LEE'S SUMMIT
MISSOURI
Development Services Department

Development Services Staff Report

File Number	PL2025-207
File Name	PRELIMINARY DEVELOPMENT PLAN – East Village Phase 1
Applicant	East Village Investors, LLC
Property Address	Approximately 130 gross acres generally located at the southeast corner of the intersection of US 50 Hwy and South M-291 Hwy
Planning Commission Date	November 13, 2025
Heard by	Planning Commission and City Council
Analyst	Hector Soto, Jr., AICP, Senior Planner

Figure 3 - Proposed monument sign locations.

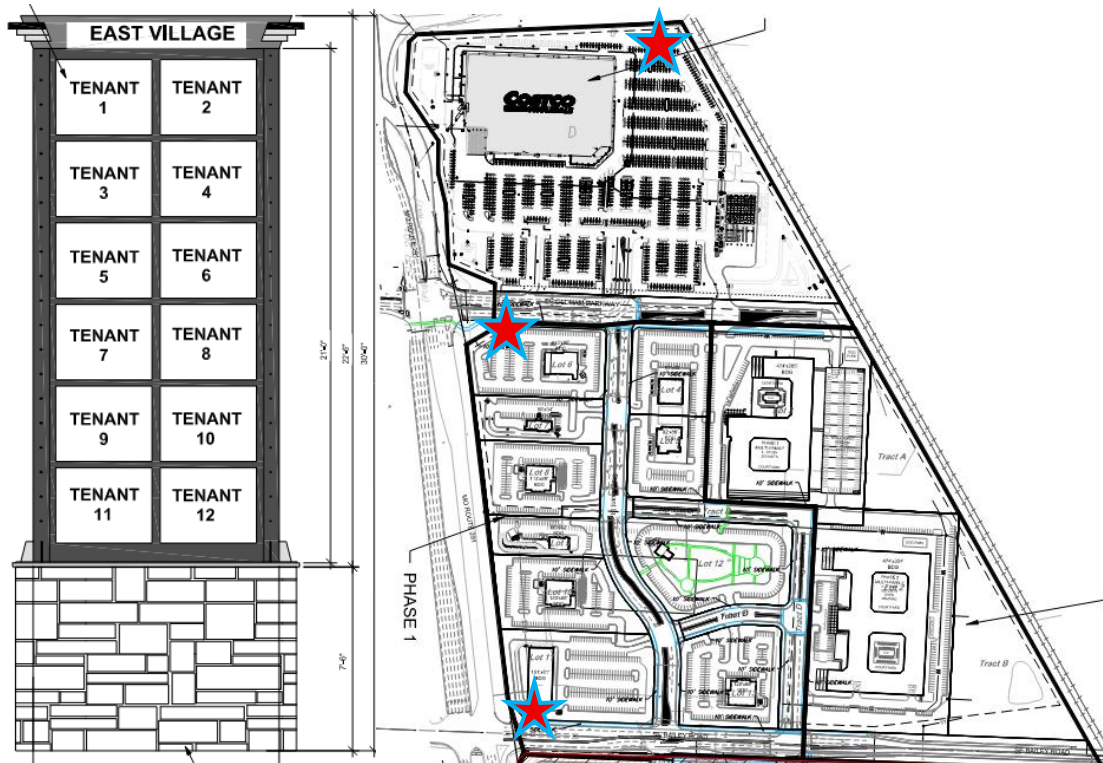
The applicant proposes an allowance for oversized monument signs, as described above, along its two highway frontages to provide a primary means of identification and wayfinding for the development near the intersection of two highways. The City Council relatively recently approved two (2) identical oversized signs for the Oldham Village development on the west side of South M-291 Hwy for the intersection of the South M-291 Hwy and SW Oldham Pkwy, and for the northwest boundary of the development facing US 50 Hwy. The City Council has also relatively recently approved two (2) oversized monument signs for a similar commercial development (Summit Orchards North) having a height of 45' and an overall sign structure size of 637.5 sq. ft. along the project site's I-470 highway frontage. Staff supports the applicant's proposal for taller and larger monument signs along the highway frontages as depicted below.

9. Approval shall be granted for three (3) oversized, primary identification monument signs in East Village Phase 1 with an overall height of 30', 224 sq. ft. sign face area and 312 sq. ft. overall sign structure area to be located at the northeast project site boundary, the southeast corner of South M-291 Hwy/SE Oldham Pkwy, and the northeast corner of South M-291 Hwy/SE Bailey Rd as depicted on the preliminary development plan October 30, 2025, and monument sign detail dated August 7, 2025.

Figure 4 - Elevation showing wall signage (east and partial southeast façade)

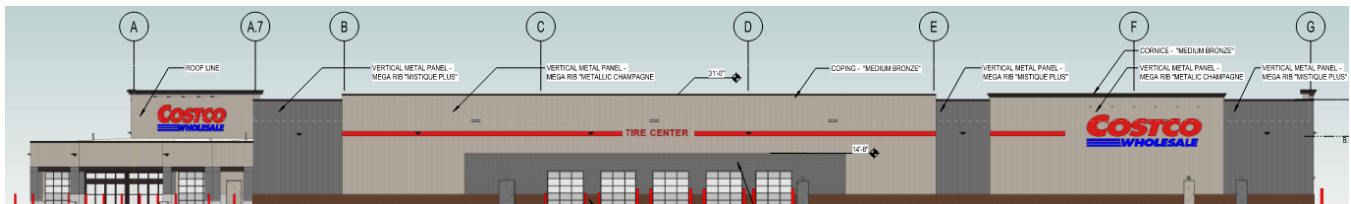
Sign Type	Number of Signs	Copy	Sign Area (10% max.)	Sign Location	Max. Letter Height
Wall signs	6	Costco	192 sq. ft. (5.4%)	Southeast Façade	5'
		Costco	290 sq. ft. (3.1%)	South Façade	6'
		Costco	290 sq. ft. (1.9%)	North Façade	6'
		Costco	290 sq. ft. (2.9%)	West Façade	6'
		Costco	290 sq. ft. (3.2%)	East Façade	6'
		Tire Center	31 sq. ft. (0.3%)	East Façade	1'-9"

10. Approval shall be granted to allow six (6) wall signs on the Costco (Lot 1) building as depicted on the building elevations dated August 8, 2025. All other lots in East Village Phase 1 (Lots 2-13) shall be subject to the governing sign standards and allowances of the PMIX zoning district.

Figure 10 - Traffic Impact Study phase areas

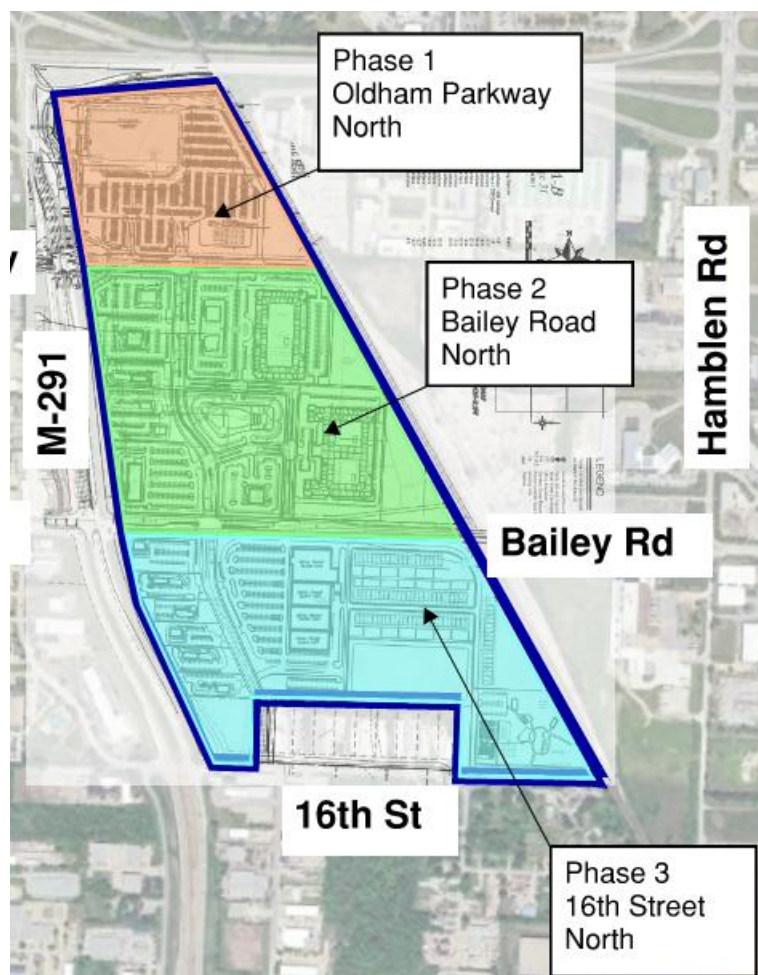
Staff supports the recommended road improvements in the TIS, but has concerns over a proposed Right-in/Right-out/Left-in access point along SE Bailey Road at the intersection with the proposed north-south collector street (identified as Node 7 in the TIS). Striking a balance between the applicant's desire to proceed with Left-in capabilities at Node 7 against staff's concern with intersection functionality and safety, condition #4 in the TIA prepared by staff is crafted to offer the applicant two options for Node 7 as it relates to a Left-in. If the Left-in is constructed, the developer shall be required to escrow \$100,000 for a period of at least 10 years for the future reconstruction of the median to limit the intersection to Right-in/Right-out only, with the decision to limit access and drawn upon the escrow for median reconstruction to exclusively reside with the City Traffic Engineer. Alternatively, if no Left-in is constructed, the applicant is only required to submit updated plans reflecting the elimination of the Left-in at the time of permit review. The applicant has been apprised of condition #4 in the TIA and is amenable to it as a condition of approval to the subject preliminary development plan.

Staff recommends approval of the proposed preliminary development plan subject to the conditions noted in the TIA. Any recommended public improvements in the TIA shall be substantially completed prior to issuance of any occupancy permit associated with the phase of development described therein.

7. Road improvements for East Village Phase 1 shall be constructed as recommended in the Transportation Impact Analysis prepared by City staff dated October 30, 2025.

Figure 12 - Trash and recycling receptacle area with evergreen landscape screening.

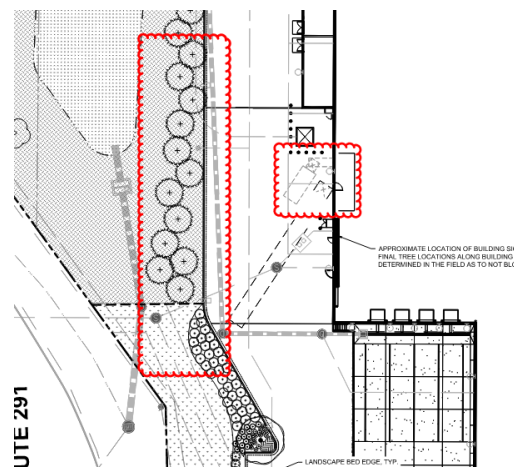
- Proposed – The trash and recycling receptacles located along the west side of the Costco building in the general vicinity of the dock area are proposed with no enclosure. In lieu of an enclosure to house the receptacles, a double-staggered row of evergreen trees and the use of evergreen shrubs along the west parking lot/drive aisle boundary parallel to the receptacles will be installed to screen the view of the receptacles from the South M-291 Hwy frontage.

- Recommended – The applicant's preferred practice for the Costco site is to provide additional evergreen landscape screening of dock areas and trash and recycling receptacle areas rather than constructing structural screens such as masonry walls in areas with high frequency of turning and backing movements by large vehicles (i.e., semis and trash trucks). Staff recommends approval of the modification request.

4. A modification shall be granted to the trash and recycling receptacle screening requirement by a masonry enclosure, to allow screening via the planting of evergreen landscape screening as shown on the landscape plans included in the preliminary development plan in lieu of masonry enclosure screening.
